Village of Cassopolis

CWSRF Interceptor Force Main Replacement

ADDENDUM 1

June 12, 2026

SA MH - 7140

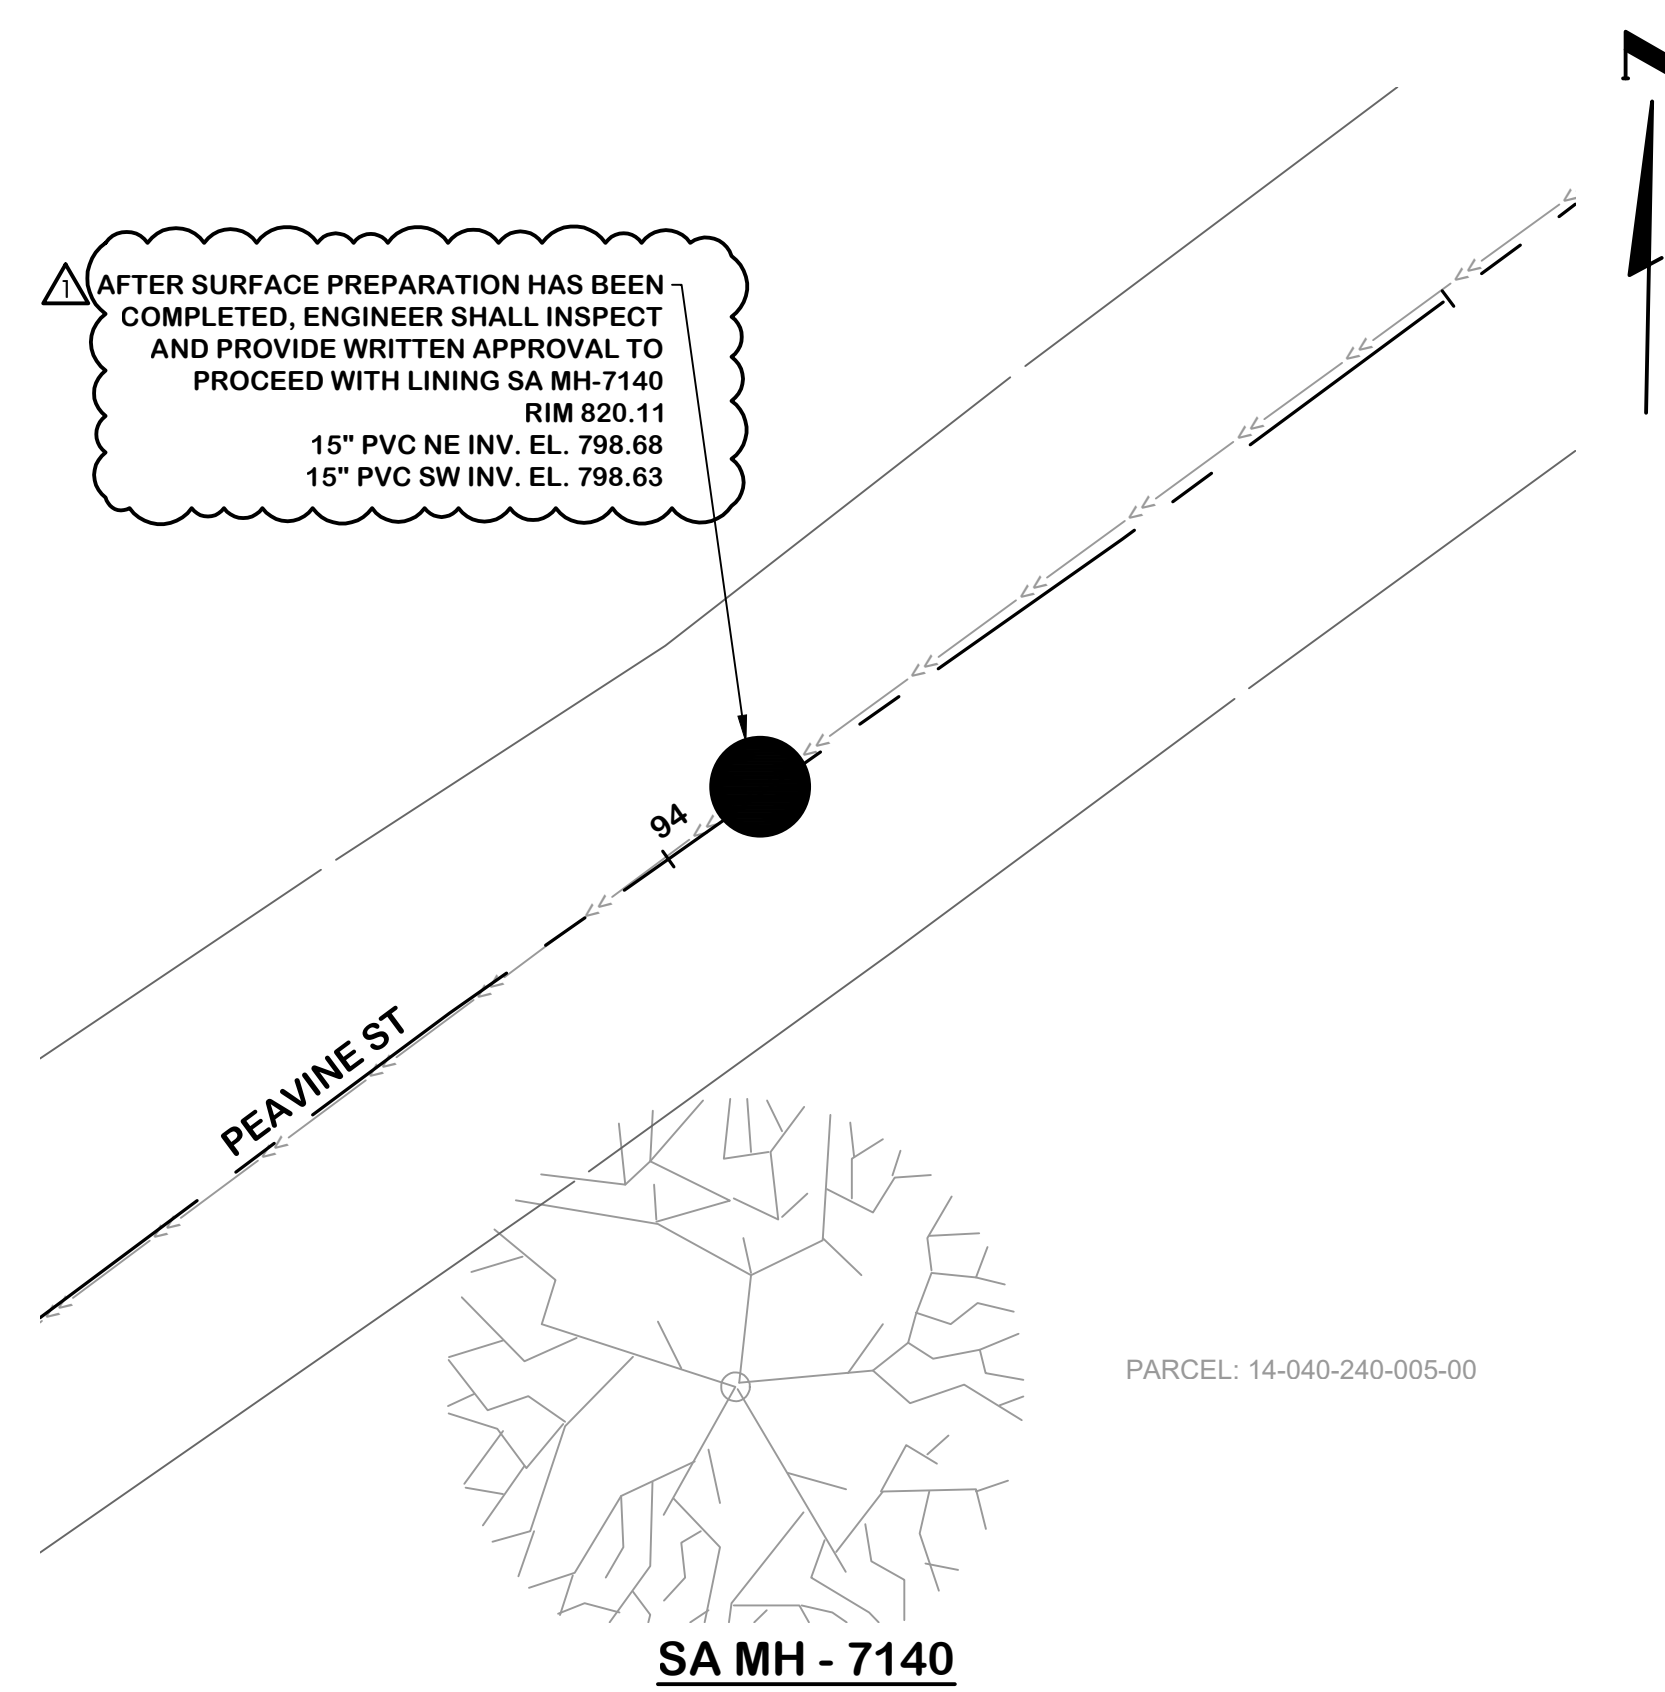
SA MH-7170, SA MH-7160, SA MH-7150, and SA MH-7140 were removed, and an additional note was added to this sheet. Replace the sheet with the provided Sheet SA-1.1 included with Addendum 1.

Sheet FM-8.1 – N Mill Street Force Main Plan and Profile Sta 0+00 to 5+00

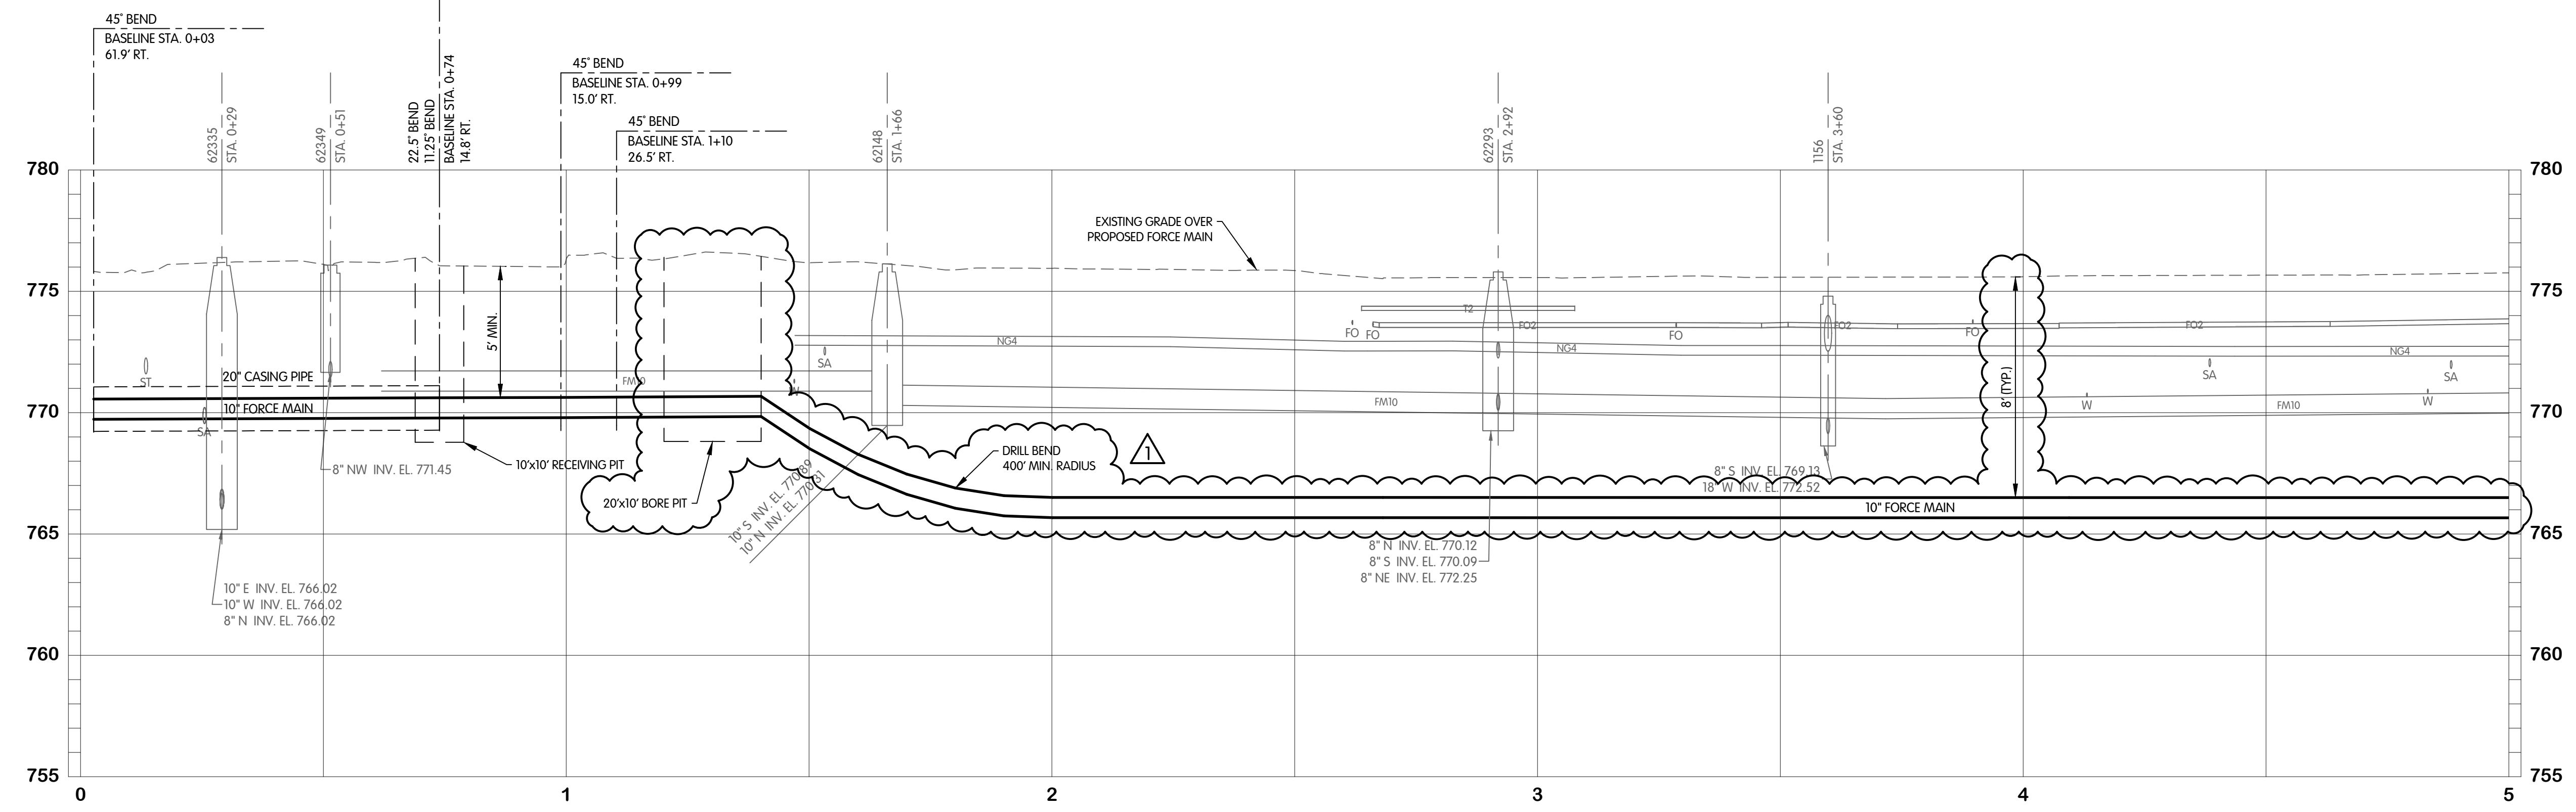
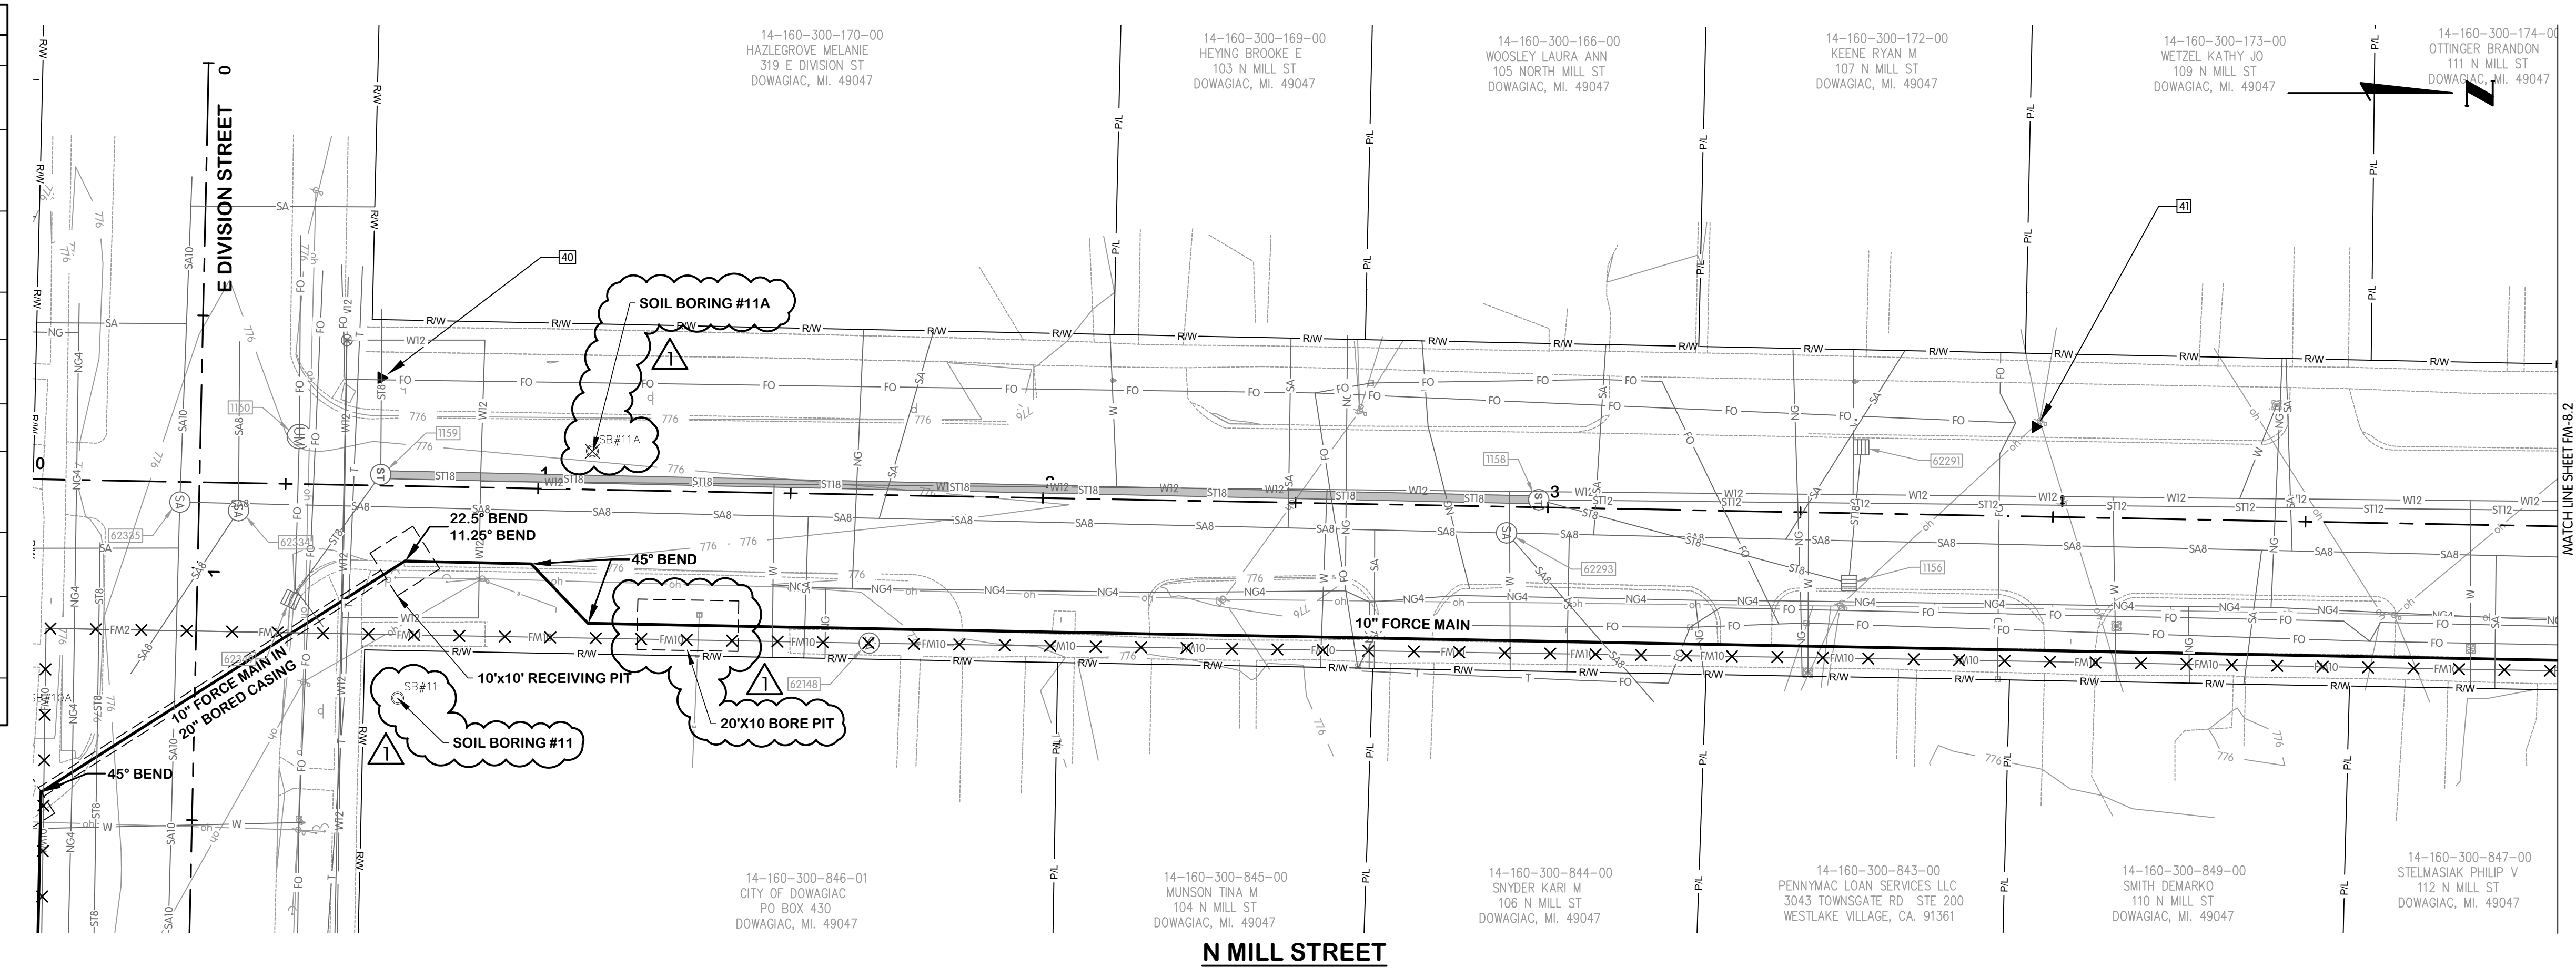
A portion of the alignment was modified and changed from open cut to horizontally-directionally drilled pipe. The north arrow was also added to this sheet. Replace the sheet with the provided Sheet FM-8.1 included with Addendum 1.

Horizontal Directionally Drilled (HDD) pipe shall be installed with a minimum bend radius of 400 feet. This note has been added to all plan sheets depicting HDD installations. Revised plan sheets will not be reissued solely for the inclusion of this note. Bidders and all relevant parties shall acknowledge and incorporate this requirement into their work and construction planning.
